**STAFF REPORT**  
**(One-Step Final Plat)**

**CASE NUMBER:** SUB 2007-10 -- MCPEAK ADDITION

**STAFF REPORT**

(One-Step Final Plat, Deferred 2/22/07 and 3/8/07)

SUBJ: McPeak Addition

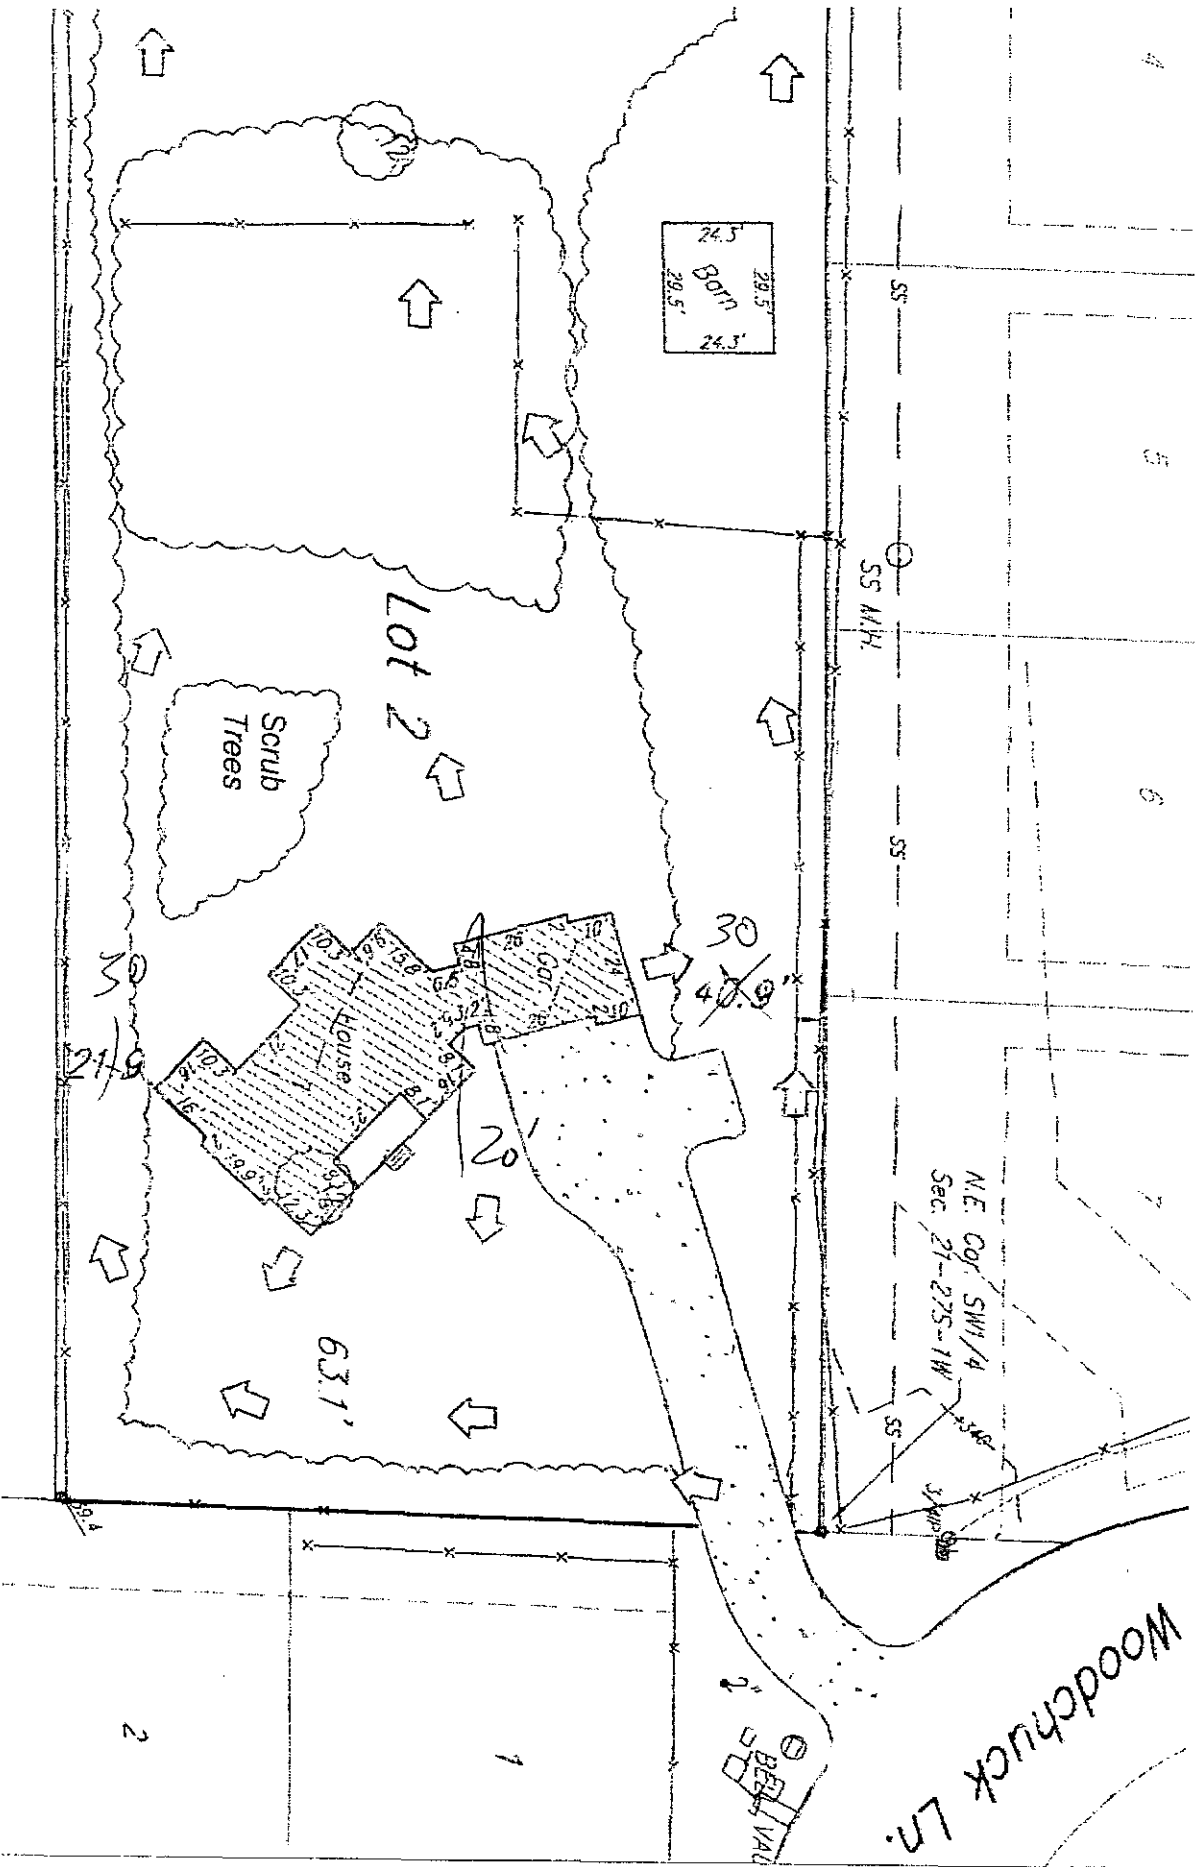
- C. As per City Engineering, the drainage plan is approved. A cross-lot drainage easement is needed.
- D. On the final plat, the MAPC signature block needs to reference the new Chair.
